TO: Mercedes-Benz Dealer Principals, General Managers, Sales Managers, Service Managers, Parts Managers	FROM: Gregory Gunther, Senior Manager, Vehicle Compliance and Analysis, Engineering Services
RE: <b>Recall Campaign Launch Notification</b> <b>Rework the Accelerator Pedal Module Bracket</b> <b>MY24 GLE (167 platform)</b>	DATE: March 22, 2024

Campaign No. 2024030009, March 2024

SUBJECT: **Model GLE (167 platform)**  
**Model Year 2024**

## **Rework Accelerator Pedal Module Bracket**

Figure 3

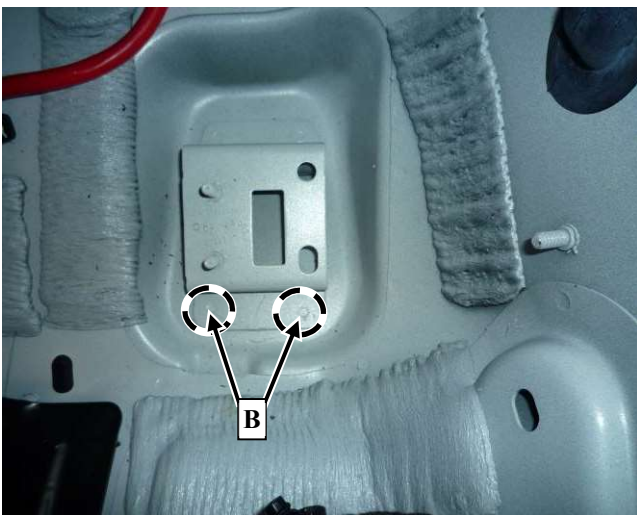
3. Drill the two lower resistance spot welds (**Figure 3, B**) on accelerator pedal module bracket using a **6.7 mm drill bit**.

Figure 4

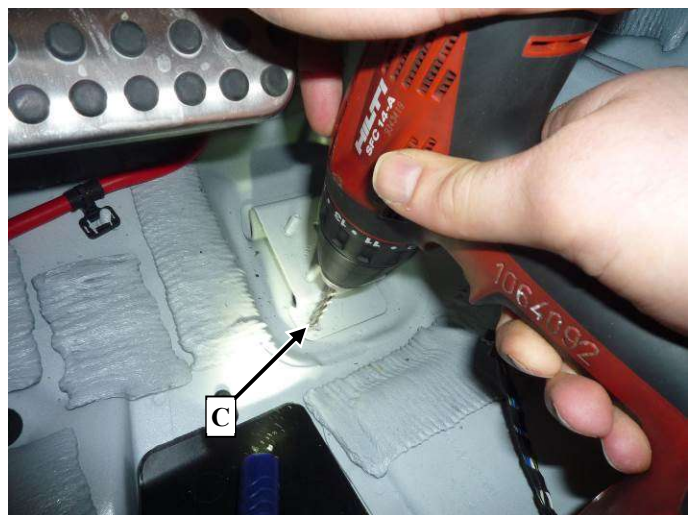
- The left-side (**Figures 4 & 5, C**) must be drilled first and then riveted (**Figure 6, D**).
- Then the right-side (**Figure 7, E**) must be drilled and riveted.

Figure 5

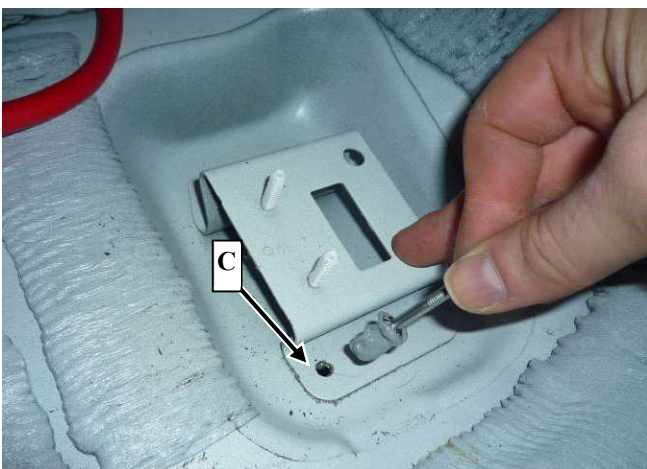
**i** The rivets **must be coated with seam seal (A 000 989 46 06)** before inserting them in the bore (**Figure 5**).

**Figure 8** (rivet D, view from below)

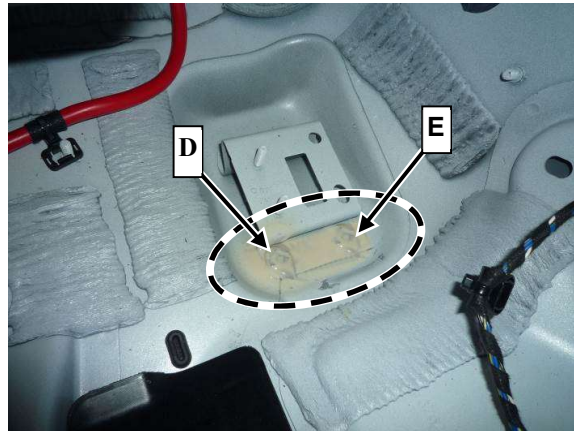
- Completed rivet should be visible from below after seam seal is applied (**Figure 8, D**)
